Subject: POPPING AND/OR SQUEAKING NOISE FROM FRONT SHOCK ABSORBER AND/OR CREAKING NOISE FROM FRONT LOWER ARM BUSHING	Bulletin No: 02-001/16
	Last Issued: 04/15/2016

2014-2016 Mazda3 vehicles (Japan built) with VINs lower than JM1BM*****304670 (Produced before November 16, 2015)

2014-2015 Mazda3 vehicles (Mexico built) with VINs starting with 3MZ

Protector Installation

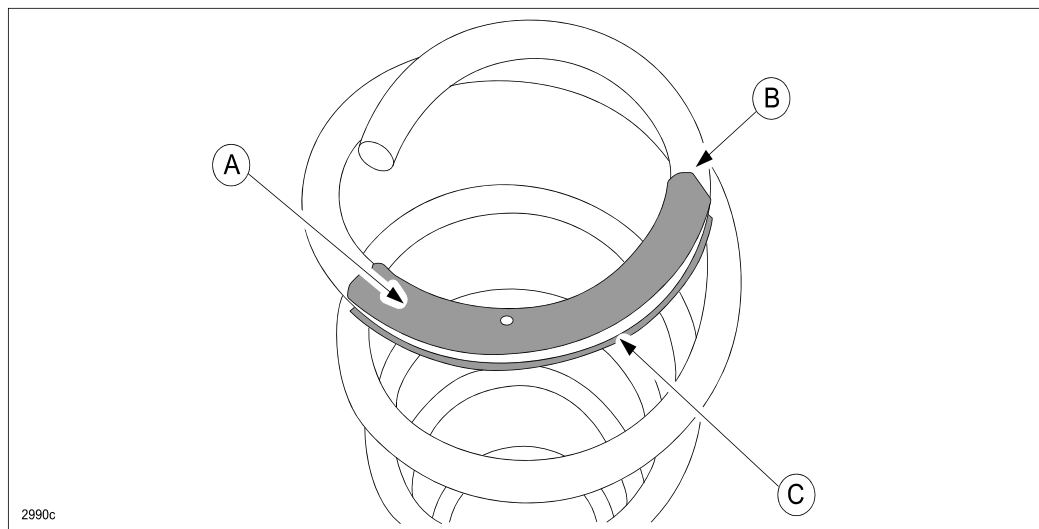
- For the squeaking and popping noise, the shape of the bump stopper has been modified and a protector has been installed onto the coil spring.
- For the creaking noise, the friction of the lower arm bushing has been reduced by adding a dry coating.

5. Install the protector (A) onto the coil spring aligning the end (slant cut side) with the marking at spot (B).
NOTE: Install the protector so the gap (C) is evenly aligned around the outer edge of the coil spring.
